| VEHICLE MODEL | : CX45 |
| SYSTEM/SUBSYSTEM | : 10.66 Body and accessories – Interior lighting equipment |
| BULLETIN TYPE | : Product Improvement |
| SUBJECT | : Stepwell lighting |

Figure 1: New installation (with controllers in junction box)

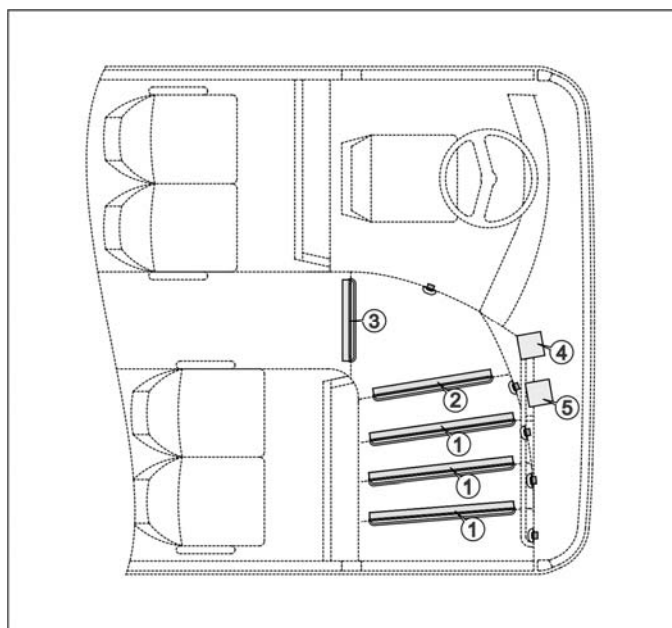
As from following unit, Van Hool has made a production change in order to increase reliability of the stepwell lighting.

1. If on units before 48244 one of the lighting strips fails, Van Hool recommends changing all five step nose lighting strips to improve the service life of the system.
2. Customers who want to upgrade their coaches to the latest specification may purchase the parts and install them as described in this Service Bulletin.

1. Step nose lighting strip, 29 inch long
2. Step nose lighting strip, 24 inch long
3. Step nose lighting strip, 16.5 inch long
4. Controller RGB
5. Controller POWERLED

Figure 2: Location of controllers in EKF junction box

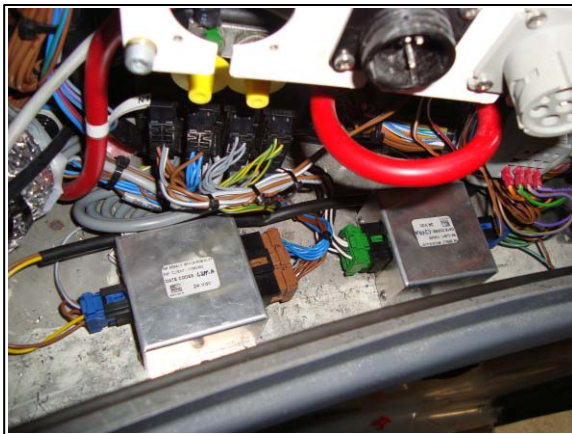
- 1) Thoroughly clean the step nose using 11357365 cleaner.
- 2) Solder the wires of the new lighting strip to the extension cable as indicated in the upper left corner of figure 3. Provide a durable and watertight connection.
- 3) Install the new step nose lighting strip with adhesive tape and install the attaching screws.
- 4) Connect the wires of the extension cables to the connectors as indicated in figure 3. Connect the connectors to the POWERLED and RGB controllers. Secure the controllers to the bottom of the EKF junction box compartment with two screws (refer to Figure 2).
